# UNITED STATES PATENT AND TRADEMARK OFFICE

10/708,186

<b>Office Action Summary</b>	<b>Application No.</b> 10/708,186	<b>Applicant(s)</b> SUTHERLAND ET AL.	
	<b>Examiner</b> Gregg Cantelmo	<b>Art Unit</b> 1745

## **DETAILED ACTION**

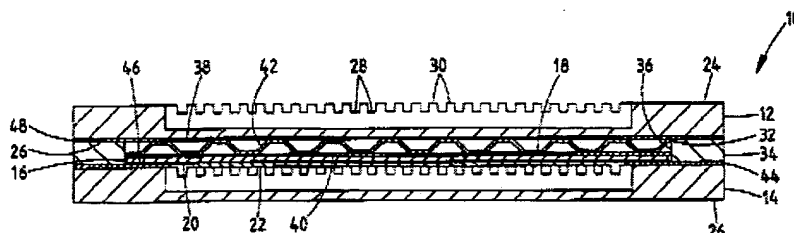
The seal element 34 defines an area where fuel passes from the intake manifold 54 such that fuel pass through and around compressible element 42 (Fig. 2 as applied to claim 4).

The interconnect 24 comprises flow directing ribs 30 in contact with an electrode surface and the conducting element 42 (Fig. 2 as applied to claim 5).

The compressible element 42 comprises nickel and the seal element 34 defines a fuel passage for diverting fuel from an intake manifold 54, through or around the compressible element and into a fuel exhaust manifold 56 (Fig. 2 as applied to claim 8).
